City of Santa Fe, New Mexico

memo

2026-012137-HDRB. 120 Camino Santiago. Downtown & Eastside Historic District, contributing, Fernando Garcia, agent for Sergio and Veronica Garcia, owners, propose to construct a 162 sq. ft. portal extension, a 16 sq. ft. addition, replace windows and doors, stucco, reroof, remove a window awning, install a HVAC, and construct 6'-0" high yard walls with gates, and other minor work. Exceptions are requested to: 14-4.6(E)(4)(I)(a) for replacing windows on a primary façade, 14-4.6(E)(4)(II) to change the stucco type, color, and finish.

Figure 3: Existing and Proposed West Primary Elevation

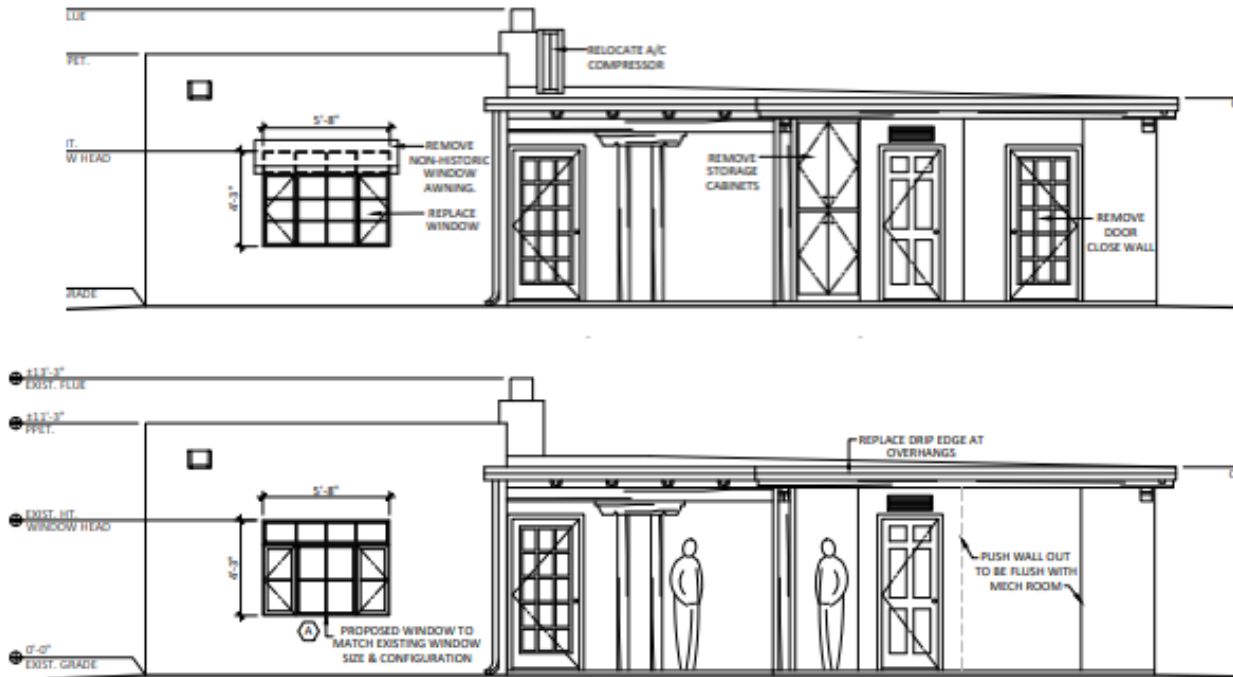
Exception to 14-4.6(E)(4)(I)(a): The applicant requests an exception to: *Historic windows shall be repaired or restored wherever possible. Historic windows that cannot be repaired or restored shall be duplicated in the size, style, and material of the original. Thermal double-pane glass may be used. No window opening shall be widened or narrowed.*

Staff Response: Staff finds that this criterion is not met. The primary façade window will be replaced to appear the same as the historic window and will not change the character of the primary façade, but will not be of the same material. The window assessment shows that the window can be repaired.

Staff Response: Staff finds that this criterion is met. The applicant does not address the hardship in their comments.

Staff Response: Staff finds that this criterion is met. The window replacement is in keeping with the recommendation of the window assessment; the window sizes will not be changed, and the publicly visible window will be divided lite, but the material will be different.
